## **DAWES POINT WEST II SUBDIVISION**

APPLICATION NUMBER 8 DATE November 17, 2011

REQUEST Subdivision

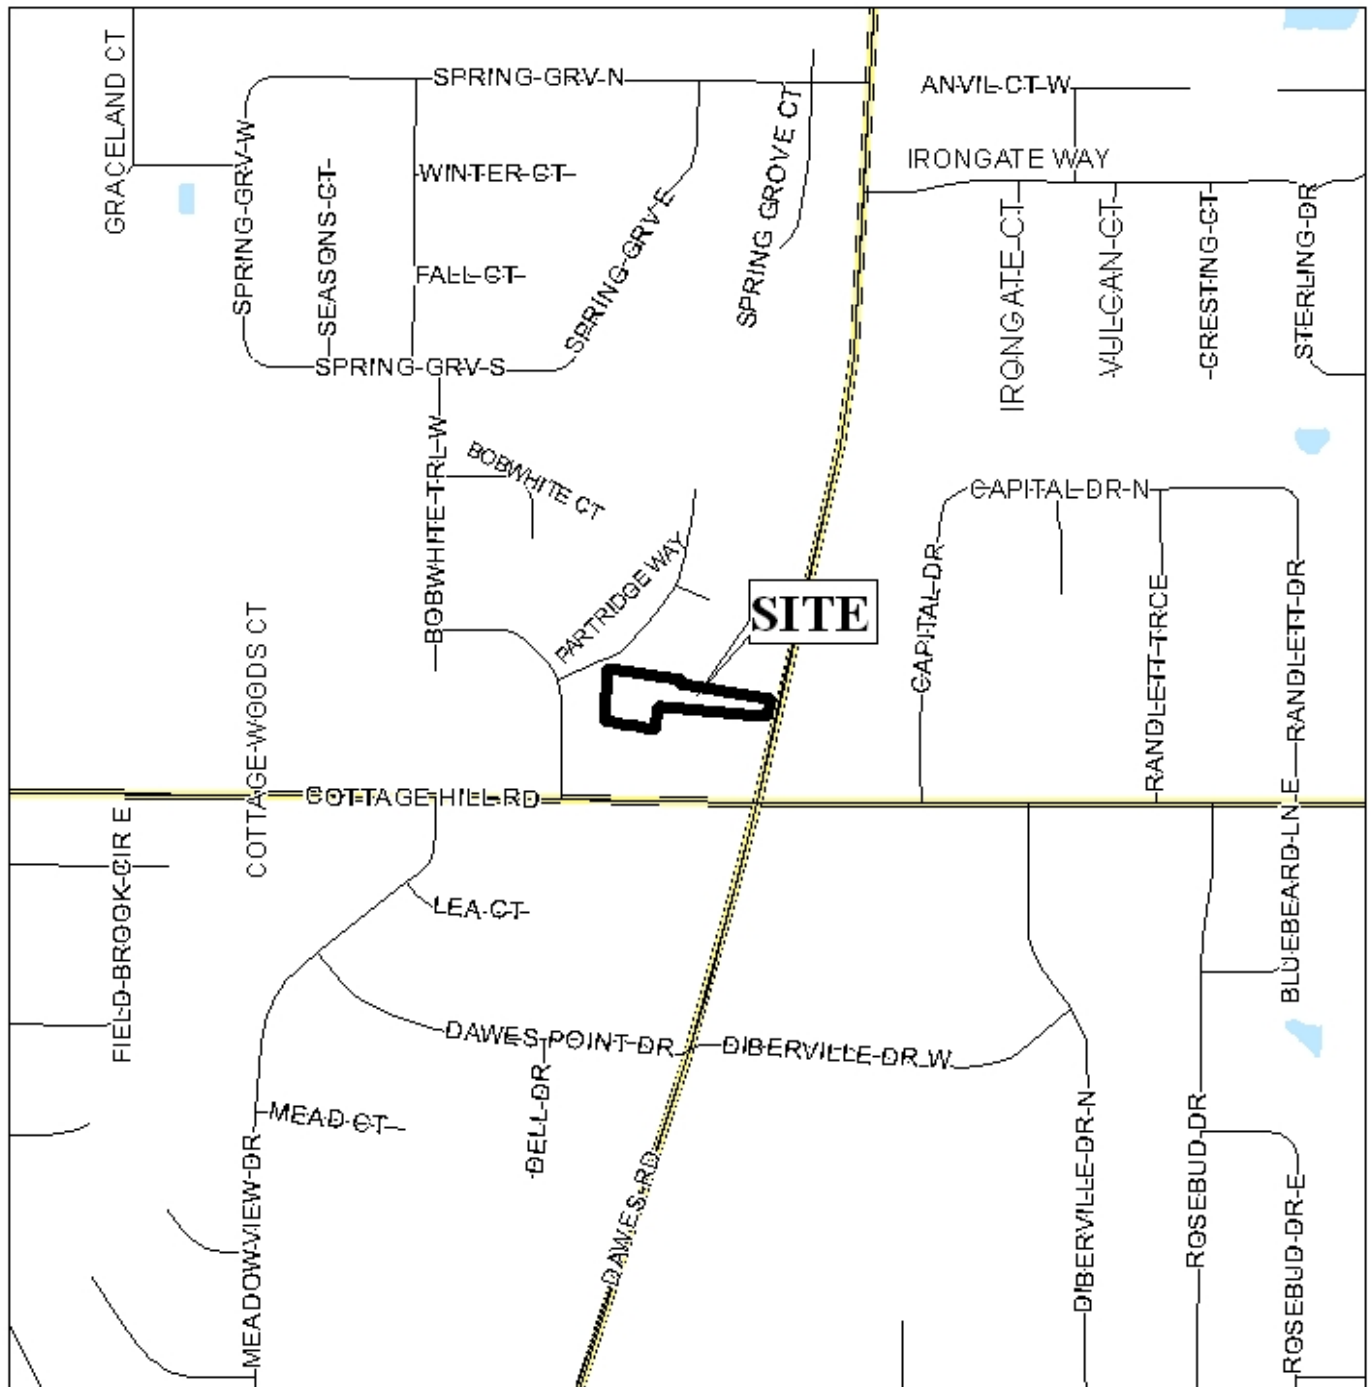
The plat illustrates the proposed 1-lot, 1.4± acre subdivision which is located at the West Side of Dawes Road, 265'± North of Cottage Hill Road, within the planning jurisdiction. The applicant states that the subdivision is served by public water and sanitary sewer.

The site is located on Dawes Road, a major street as shown on the Major Street Plan. The preliminary plat illustrates that the right-of-way varies along Dawes Road; however, as a major street, a 100-foot right-of-way is required. If approved, a dedication to provide 50-feet from the center line should be required.

The lot size is not labeled on the preliminary plat; therefore, this information should be placed in square feet and acres, on the Final Plat, if approved. However, it appears the proposed lot would exceed the minimum required lot size in Section V.D.2. of the Subdivision Regulations.

It should be noted that the proposed lot is 66'± wide at the building setback line and 580'± deep. Section V.D.3. of the Subdivision Regulations states that the maximum depth of any lots, exclusive of unusable land shall not be more than 3.5 times the width at the building setback line. Using this calculation, the proposed lot is 349'± deeper than allowed.

The 25-foot minimum building setback is not shown on the preliminary plat. The setback should be illustrated and labeled on the Final Plat, if approved.

If approved, a note should be placed on the Final Plat limiting the lot to one curb cut to Dawes Road with the size, design, and location of all curb cuts to be approved by Mobile County Engineering and conform to AASHTO standards. The site borders Partridge Way, and a note should be placed on the Final Plat stating that the lot is denied direct access.

- 1) dedication to provide 50-feet from the centerline of Dawes Road;
- 2) depiction of the 25-foot minimum building setback line from all public right-of-ways, as required by Section V.D.9. of the Subdivision Regulations;

- 3) placement of a note on the Final Plat limiting the lot to one curb cut to Dawes Road, with the size, design, and location of all curb cuts to be approved by Mobile County Engineering and conform to AASHTO standards;

- 4) placement of a note on the Final Plat stating the lot is denied direct access to Partridge Way;
- 5) labeling of the lot area size, in square feet, or provision of a table on the Final Plat with the same information;
